**EASTERN CONNECTICUT  
ENVIRONMENTAL  
REVIEW TEAM  
REPORT**

**FENNER  
ESTATE  
SUBDIVISION**

**STONINGTON, CONNECTICUT**

**REVIEW DATE : JUNE 8, 1989**

### BEDROCK GEOLOGIC MAP

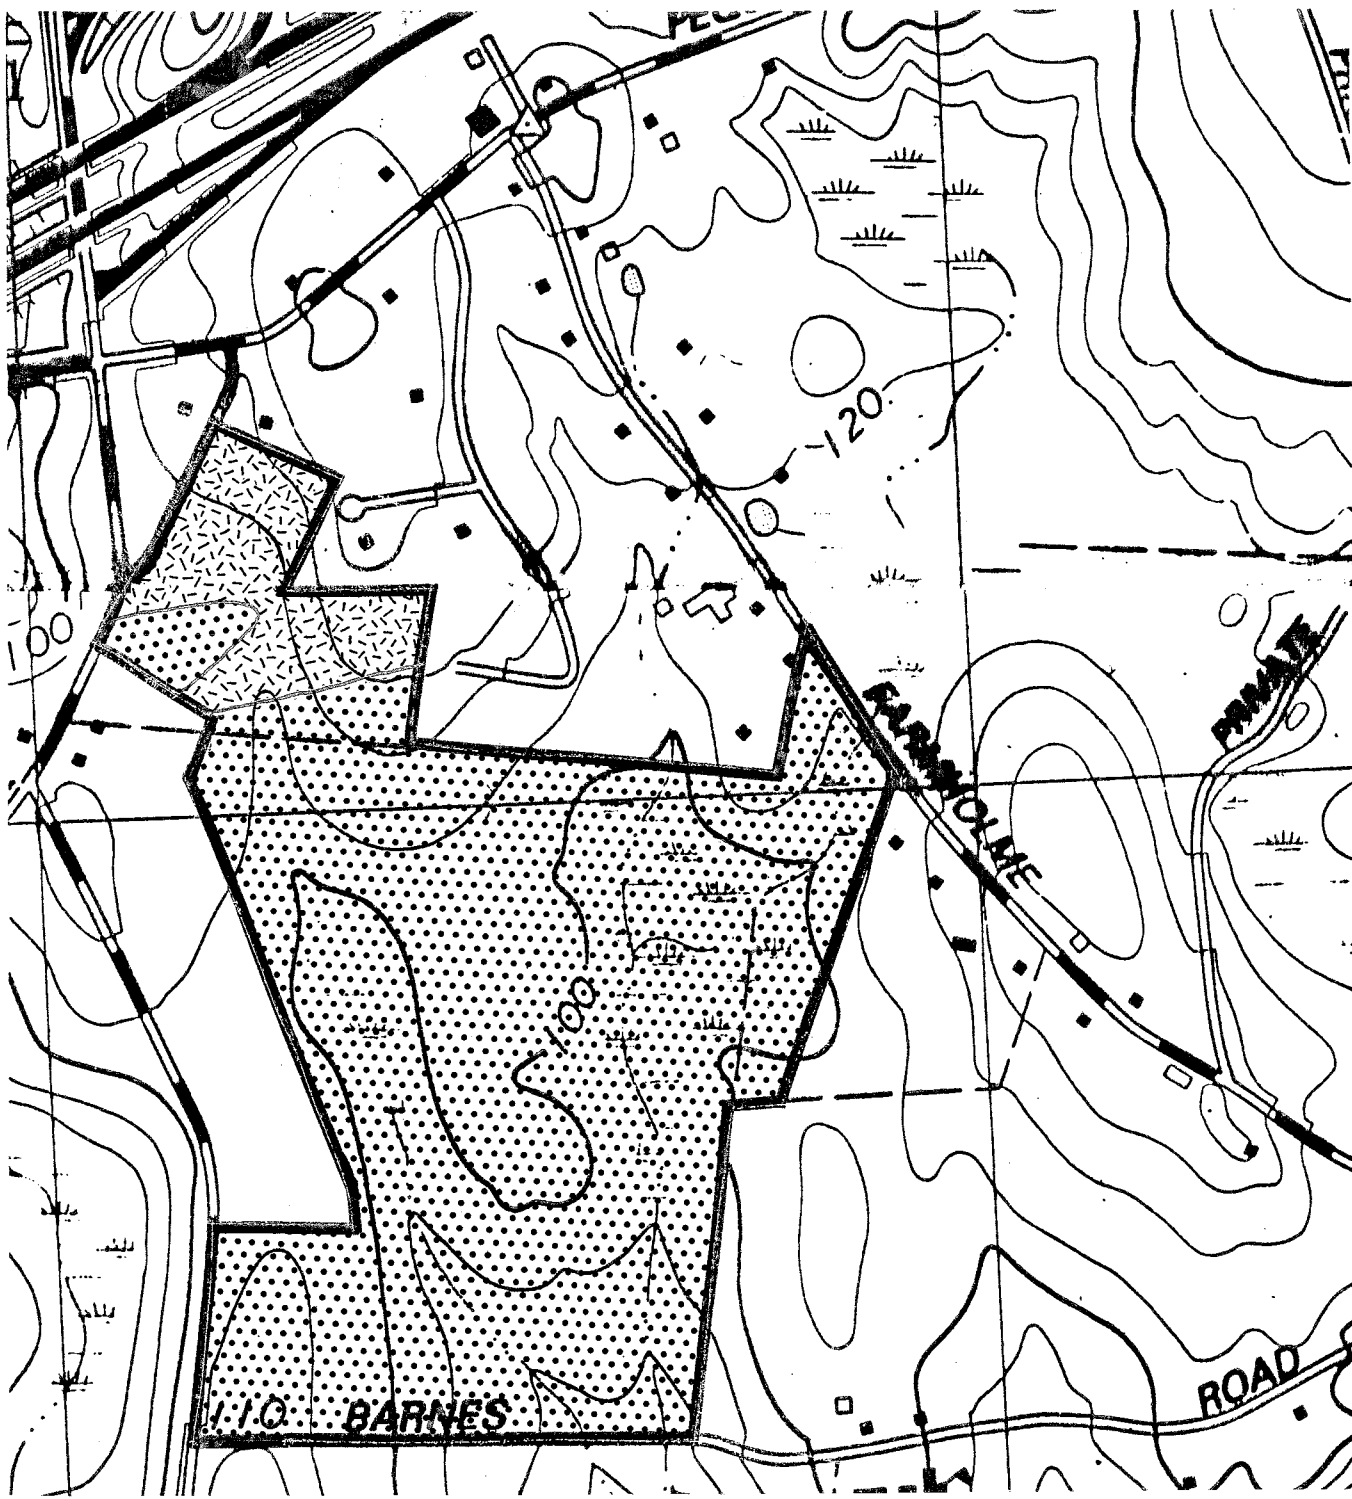
Two subunits within the Mamacoke Formation have been identified on the site. The majority of the site is underlain by a hornblende-biotite gneiss. The northern limits are underlain by a biotite gneiss. The latter rock unit is more susceptible to the weathering than the hornblende-biotite gneiss. Because of the high percentage of the mineral biotite in the rock, it tends to weather to low ridges and swales. In general, gneisses are coarse grained metamorphic rocks, geologically altered by heat and pressure commonly with strong layering (foliation).

Based on deep test hole information supplied to Team members, the bedrock surface is shallowest on Lot 10 (Test Hole 3A) where it was possibly encountered at a depth of 6 feet. Bedrock is probably 10 feet thick or less throughout the parcel.

**SURFICIAL GEOLOGIC MAP**

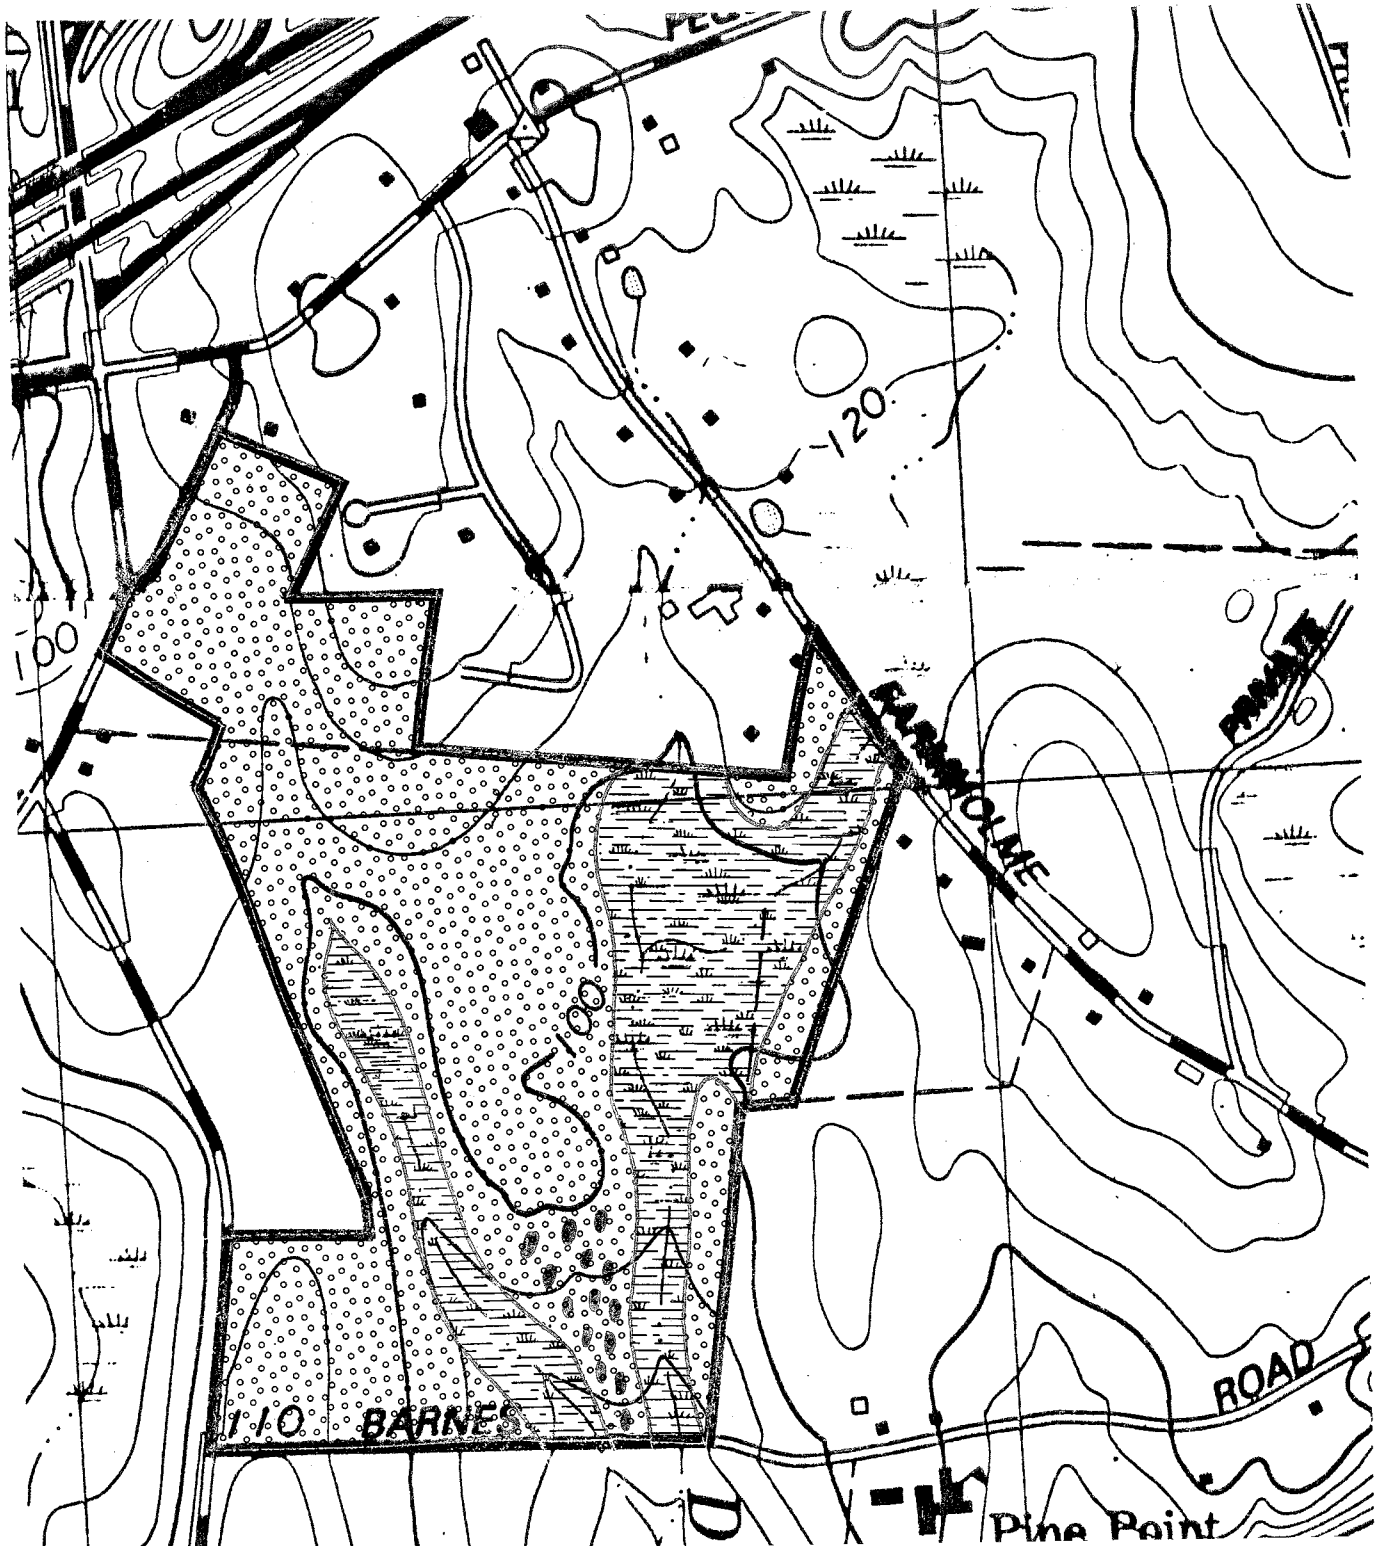
The subdivision site is covered entirely by a glacial sediment called till. It was deposited directly by an ice sheet whose front extended to Fisher's Island. The till consists of varying proportions of sand, silt, gravel, clay and boulders. Particles of different sizes are generally mixed together in a complex fashion.

The texture of the till on the site is sandy and gravelly and tightly compact. In general, it is grey in color. The compact zone is encountered below the weathered and rooted surficial soil zone (2-3 feet below ground surface). Above the compact soil zone the texture of soil is typically loose or only moderately compact. The discussion in the preceding sentences is based on interpretation of deep test hole data supplied by the applicant's engineer.

Because the compact soil zone is slowly permeable, there is a tendancy for seasonal high water tables to occur above the compact or "hardpan" layer during the wet time of year. Additionally, the compact soil zone is slowly permeable characterized by a slow percolation rate. As a result, if septic systems are not properly designed, constructed and maintained in areas characterized by a seasonally high water table condition, the chance for septic system failure will be high and the potential for ground and surface water contamination will be enhanced. (See SEWAGE DISPOSAL Section).

A bouldery area characterizes the central parts of the site. The removal of large stones and boulders for landscaping and septic system will be necessary in this area.

**SOILS**

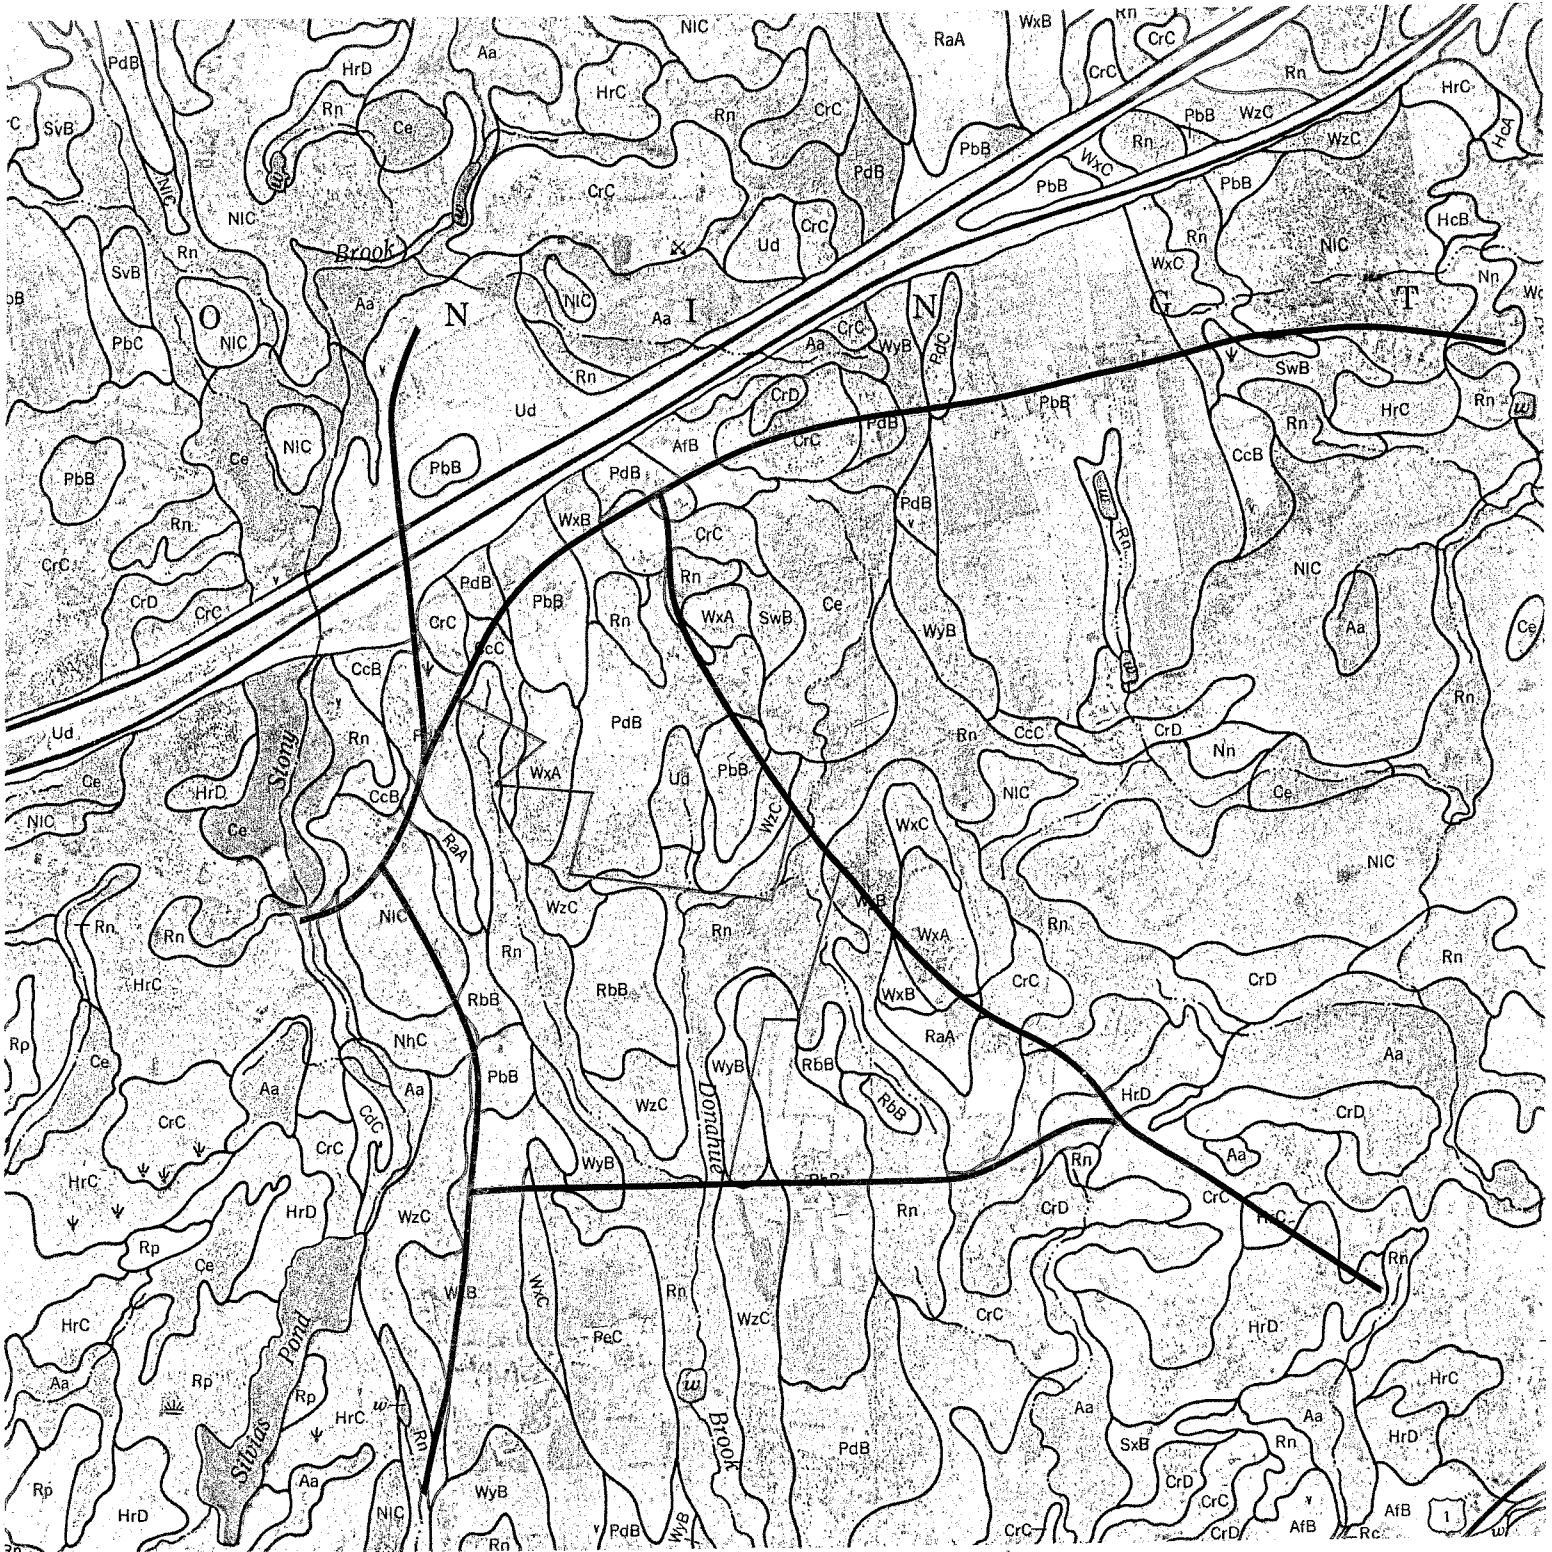
It should be noted that excluding wetland soils on this site, the majority of the soil mapping units are considered prime agricultural soils. Refer to the soil descriptions and the soil test pit data for specific information on soil characteristics. Evidence of a high water table is displayed by mottling. Engineered septic systems may be necessary at these sites to prevent downslope seepage of effluent. Foundation drains are also necessary. Wetness and slow percolation rates dominate these soil types.

**WATERSHED BOUNDARY MAP**

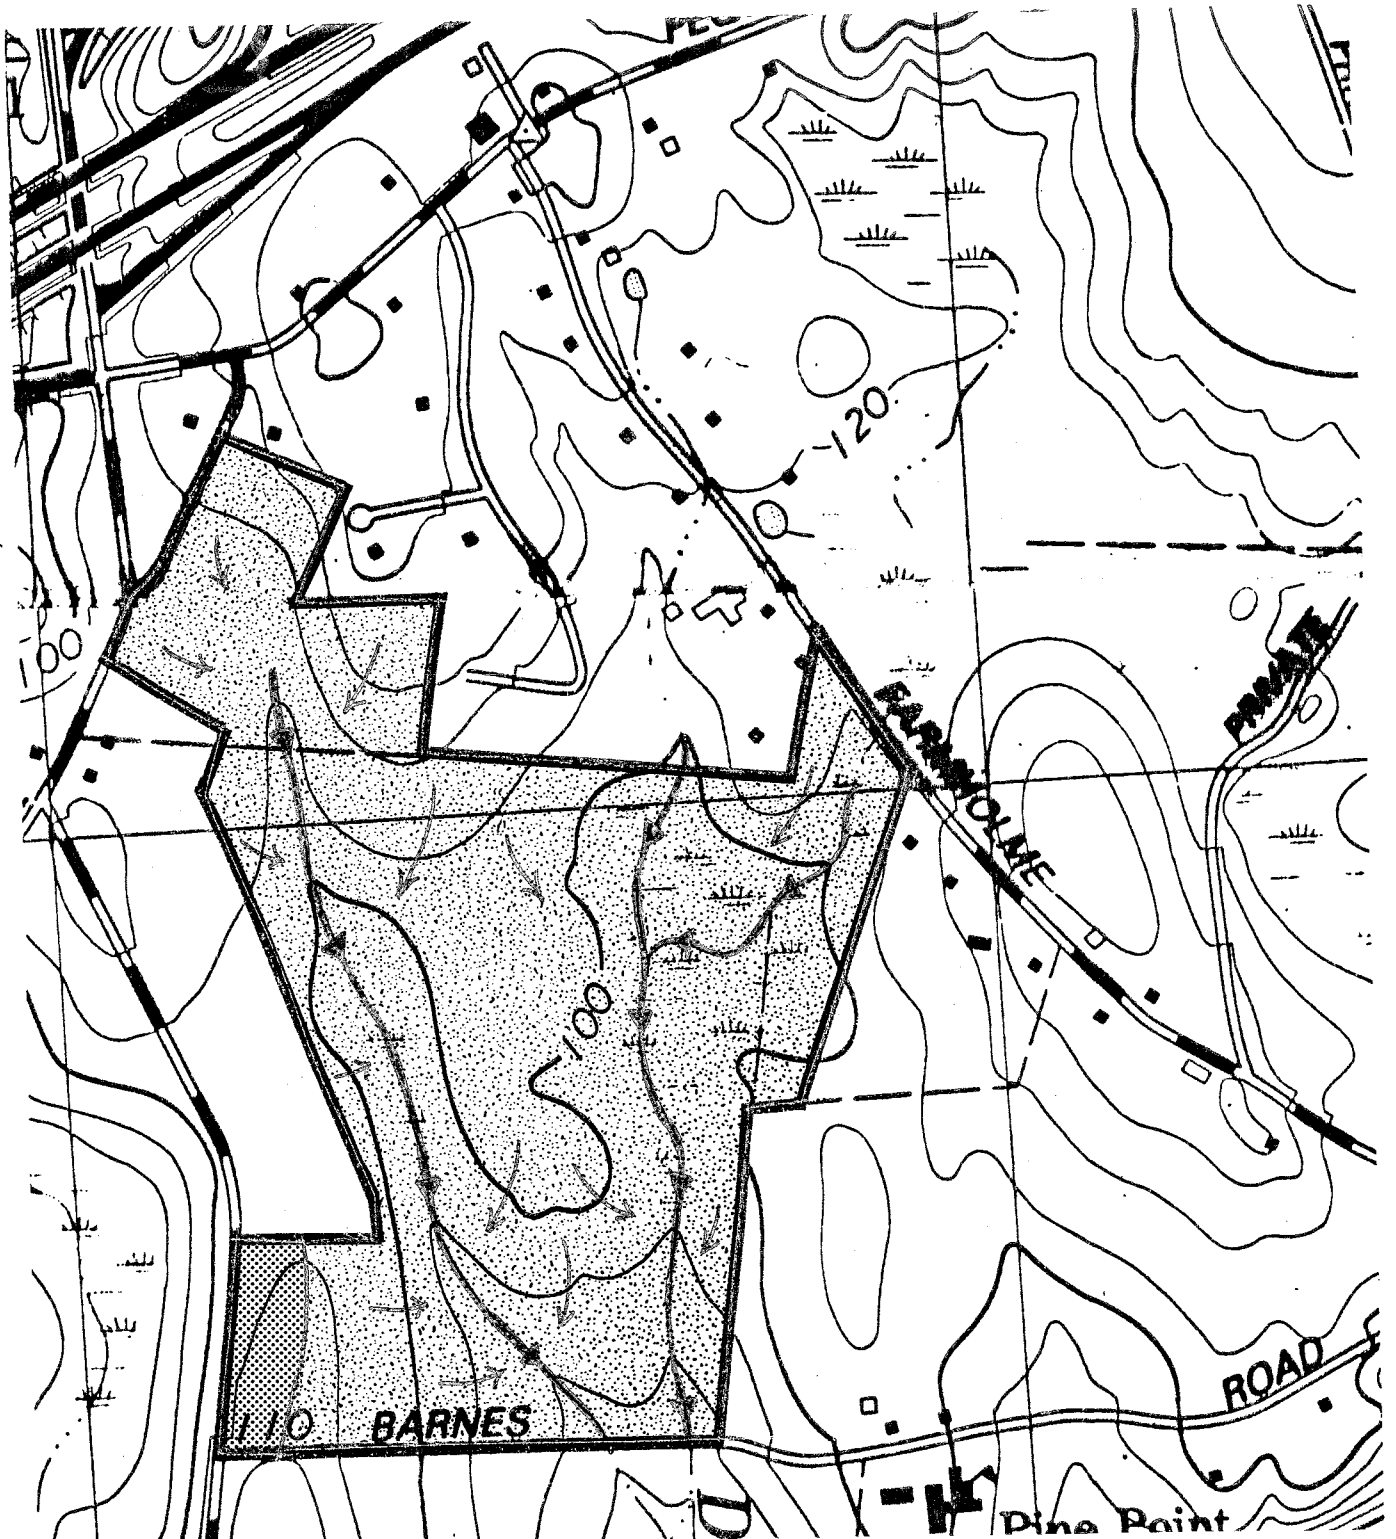
Except for the southwest corner, the site is located in the Donahue Brook drainage area. The western parts of the site drain into Silvias Pond southwest of the site. This outlet stream for Silvias Pond is Story Brook. However, at its point of outflow into Wequetequock Cove, Donahue Brook drains an area of 1.62 square miles or about 1037 acres. The site, therefore, represents about 10% of the drainage area.

Since the density of homes proposed is low and no interior road system proposed, the increase in post development runoff should not be significant. The broad, flat wetlands on the site will also provide natural storage capabilities for handling post-development runoff increases from the subdivision. Careful examination of the culverts passing under Barnes Road is warranted. Team members were informed that flooding occasionally occurs in this area. Every effort should be made not to aggravate this condition.
